CITY OF PORTLAND, OREGON

# Staff Presentation to the **Portland Design Commission**

## Design Review Hearing LU 15-156716 DZM **Oregon Square**

August 13, 2015

## HISTORY

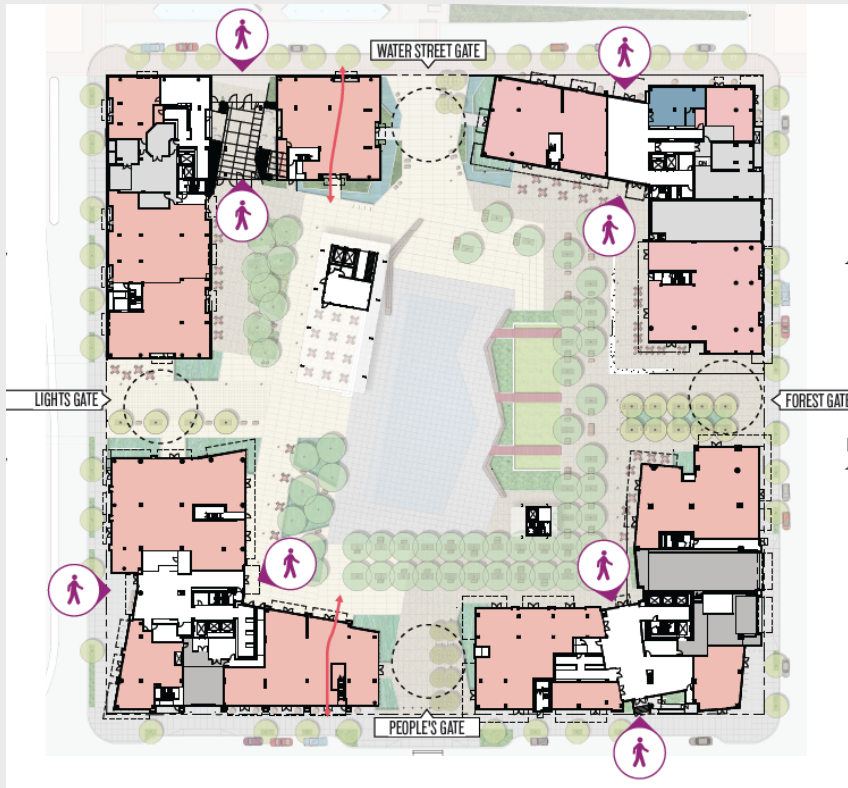
DAR concerns – porosity, hierarchy of portals reflect N-W  
pedestrian connection thru district, response to the LRT platform

## DAR concerns

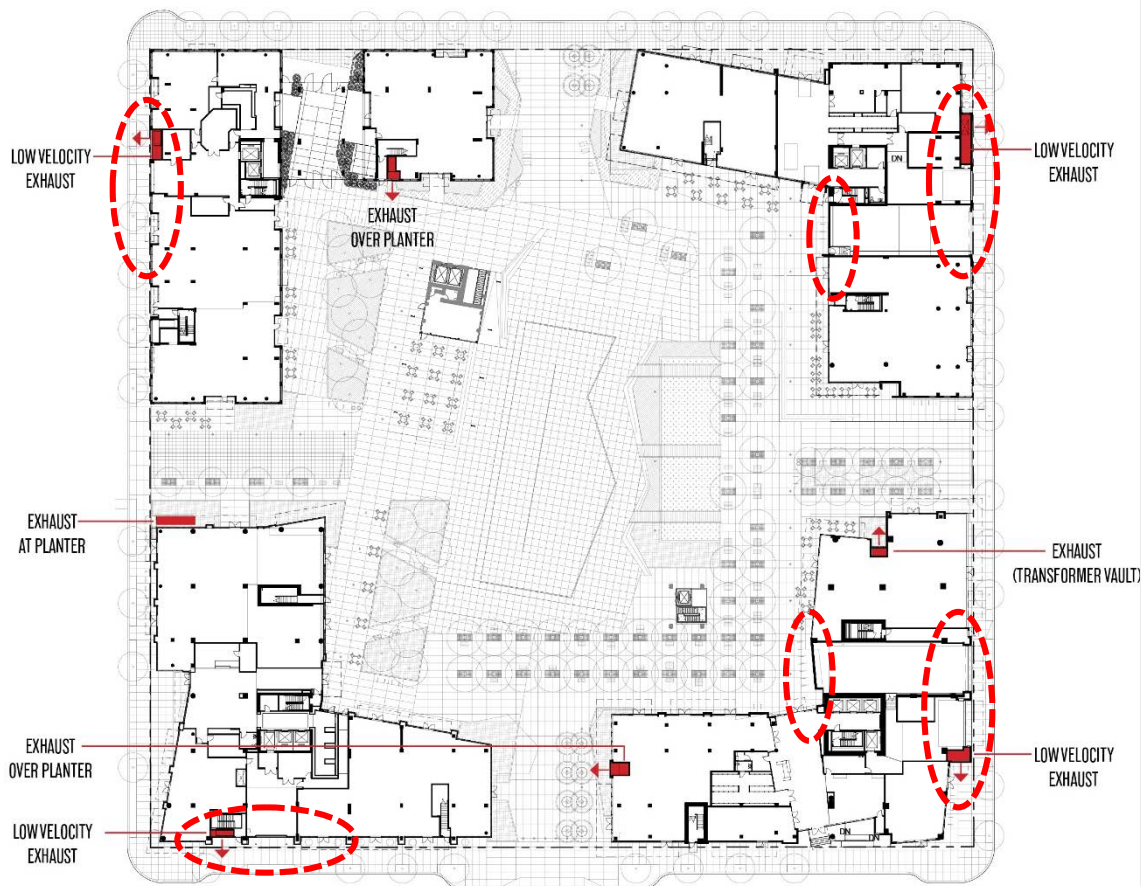
- why would people want to go there (programming & attraction)
- Preference to shift mass from SW to NE to allow more sun into plaza
- If ground level edges around plaza needed to be the same

- Set some parameters for the (min. size, number, type and location) and either add COA or return Type 2 review
- More information/details on the programming of the plaza (synergy from Phase 1)
- No shifting of mass or sun/shadow studies, reduced density of trees at NE corner
- No changes to ground level transitions along building edges facing plaza

## Block 90 (SW)

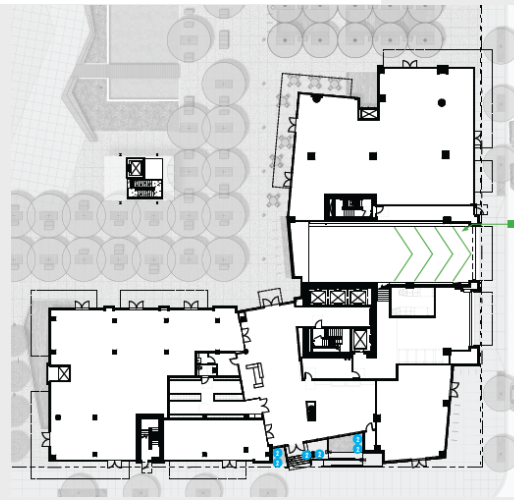
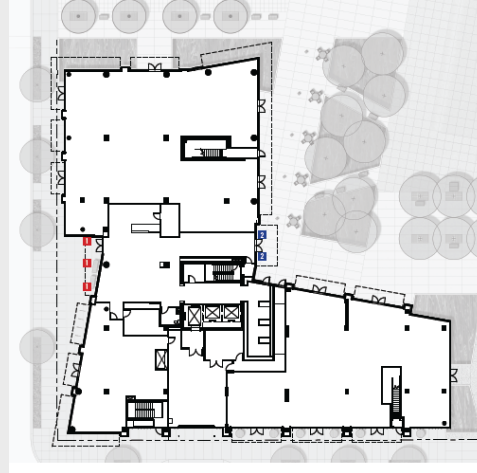
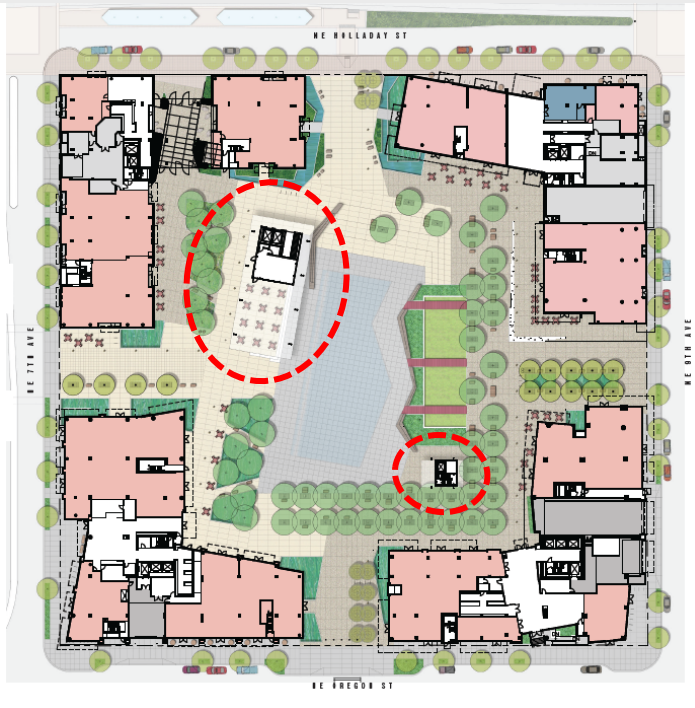
- Primary DAR concerns (building form & massing)
- Dark color
- Exposed fasteners on primary building exterior finish (smooth reinforced thin concrete panel)

- Exploit verticality
- Embrace tower coming to ground
- Questioned sidecar
- Integrate horizontal balconies
